**INOVA' FAIR OAKS
HOSPITAL**

Reference: NRC license # 45-24876-01

Inova Fair
Oaks Nuclear
Medicine

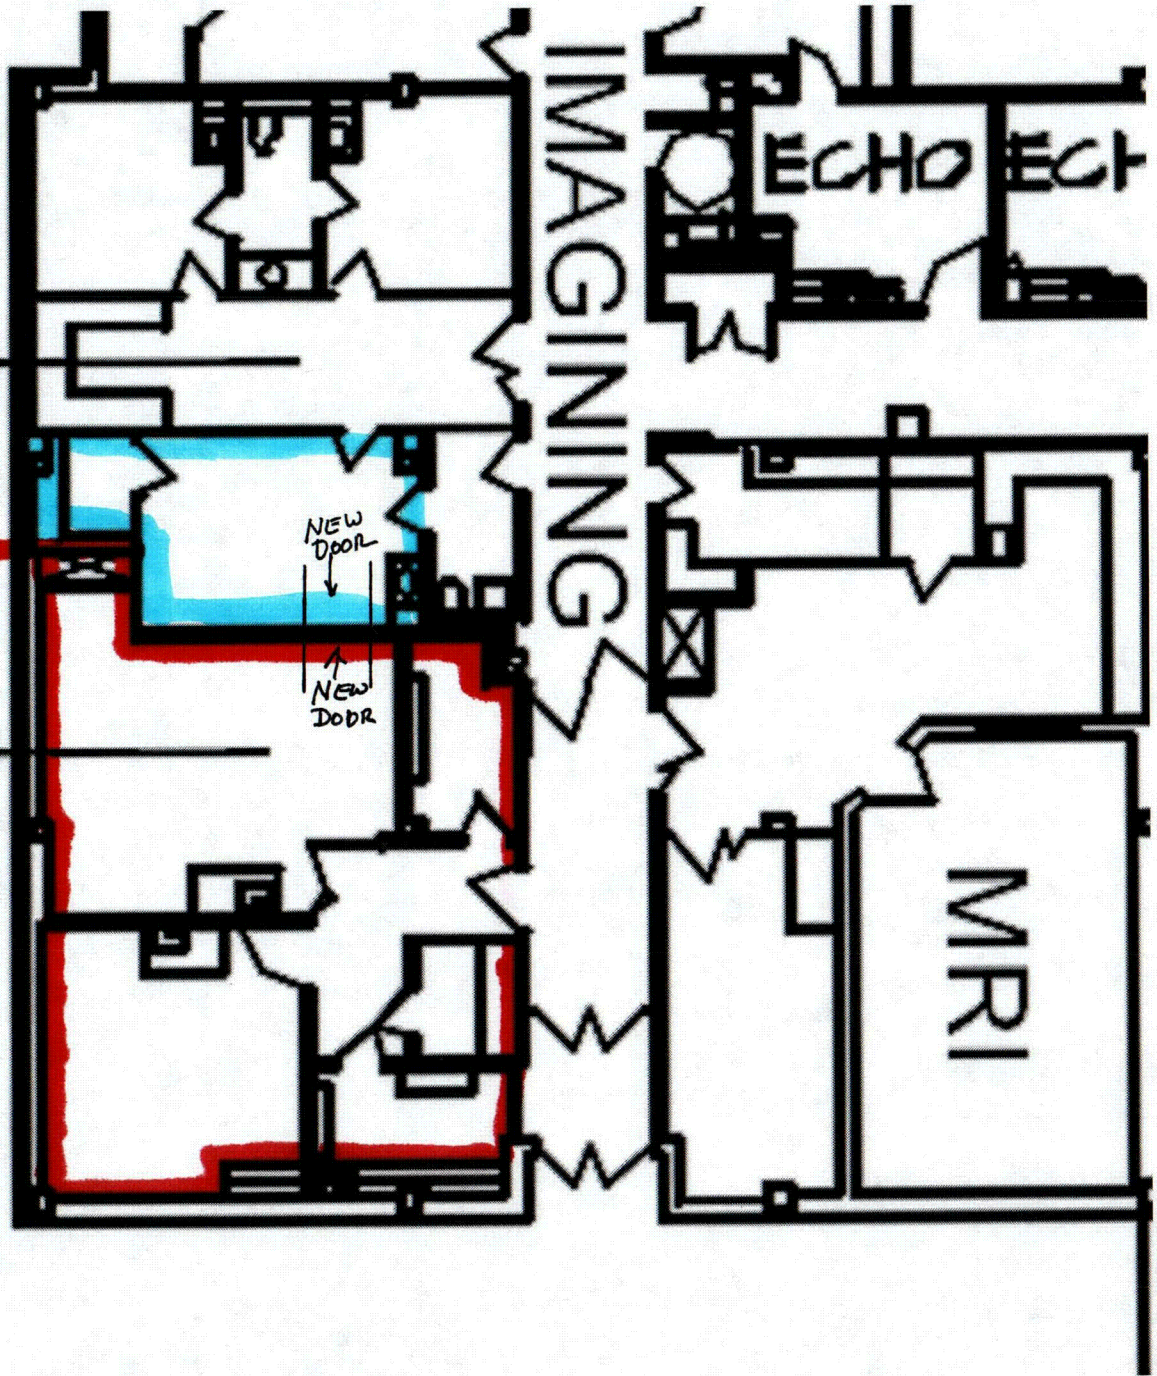
A reconfiguration of the existing facilities has allowed us to add an additional workspace available for Nuclear Medicine procedures. Attached is a modified floor plan to show the location of this modified room. The areas outlined in red are the areas currently indicated on our NRC license. The areas outlined in blue are the new areas. The new doorway has been created as a passageway between these two areas.

- (1) To be used primarily as a nuclear cardiac stress testing area
- (2) There will not be storage of radiopharmaceuticals in this room (other than radiopharmaceuticals under direct staff control and intended to be injected into the patient)
- (3) The small room attached to this area is a storage closet. It is used as a non-radioactive storage area.
- (4) All movement of radiopharmaceuticals into this room will be through the new access doorway
- (5) All requirements and license conditions currently in effect will also apply to this new area, including the requirements of 10 CFR 35.70: Surveys of ambient radiation exposure rate.
